ADDENDUM NO. 02

Baggage Screening Improvements – Phase 2B
[Baggage Handling Building Addition and OSR Room]

PROJECT NO. A044-09002-02

DATE OF ADDENDUM: February 07, 2012

1 PARTIAL GRADE LEVEL FIRE PROTECTION PLAN - NORTH
3/32" = 1'-0"

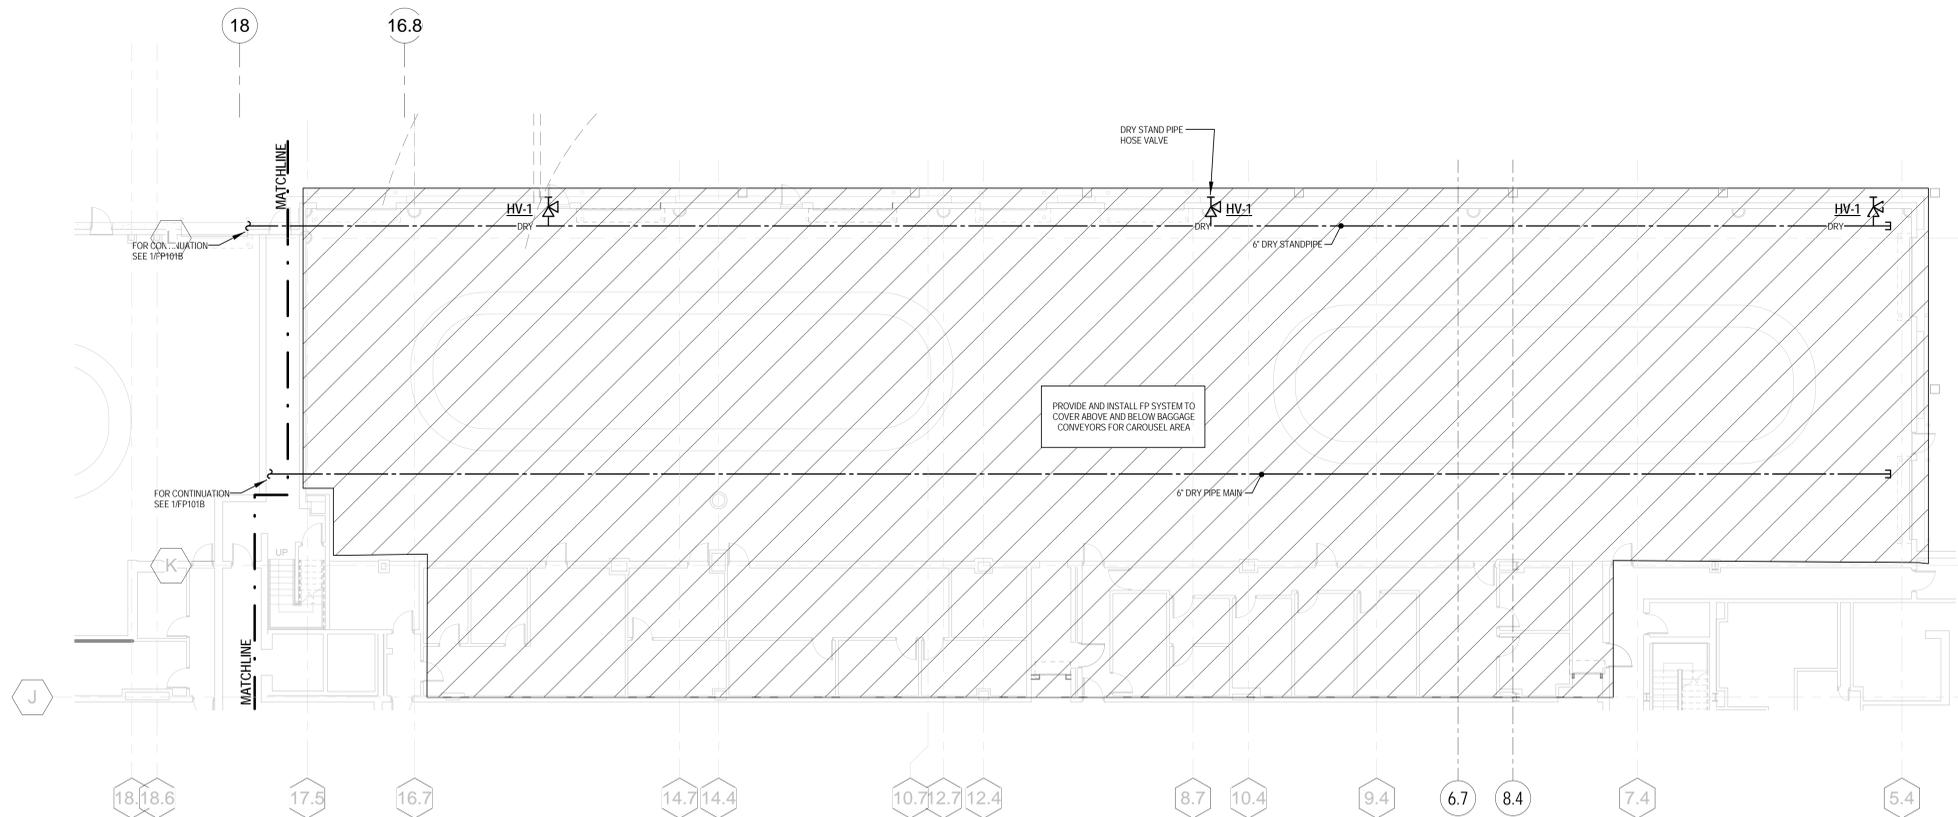
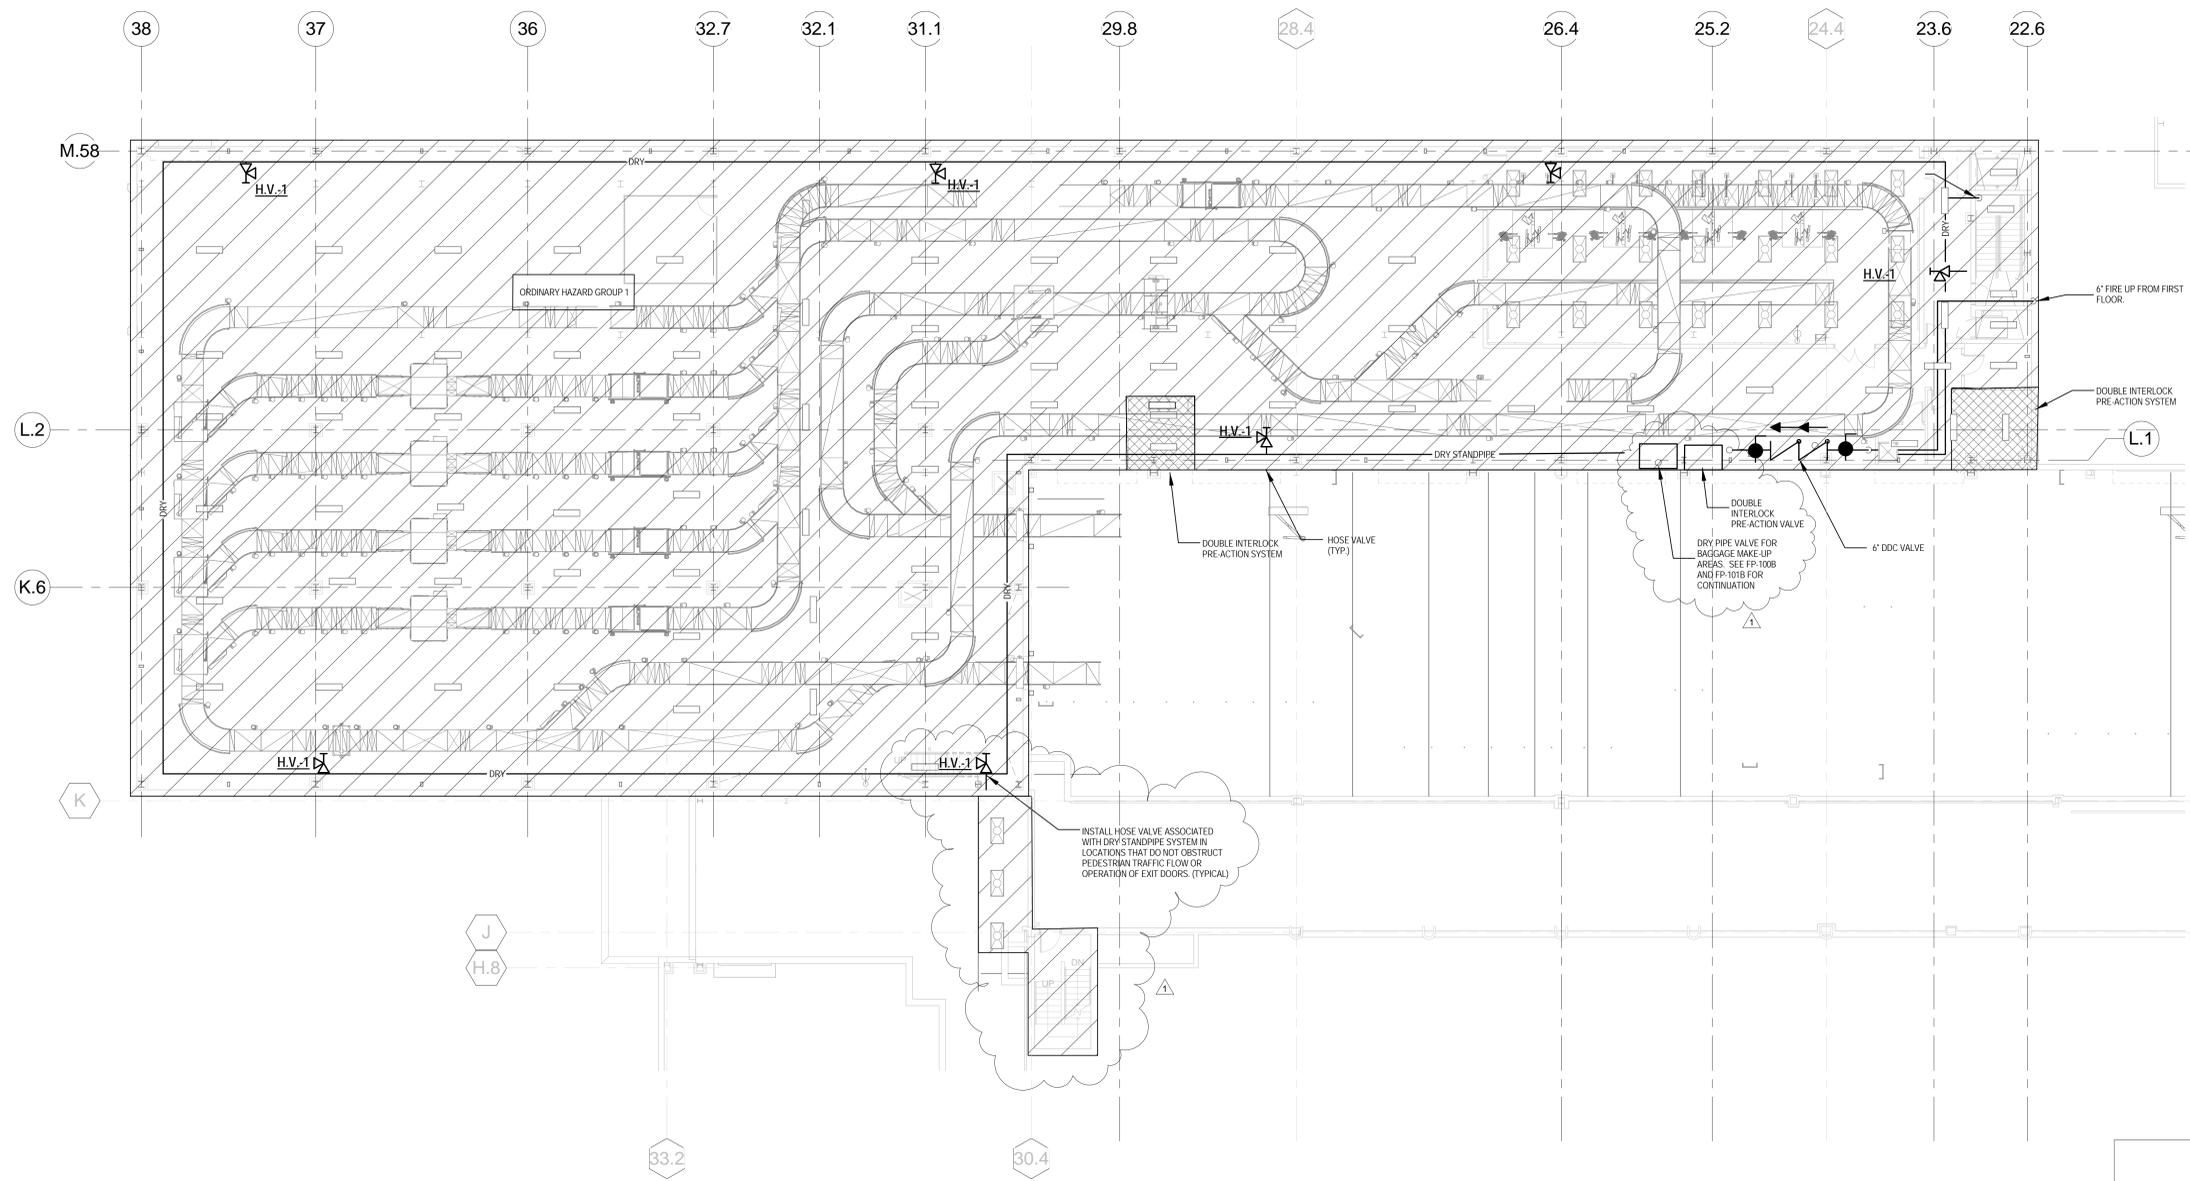
ADD Sheet **FP101B PARTIAL GRADE LEVEL FIRE PROTECTION** to the drawing set.
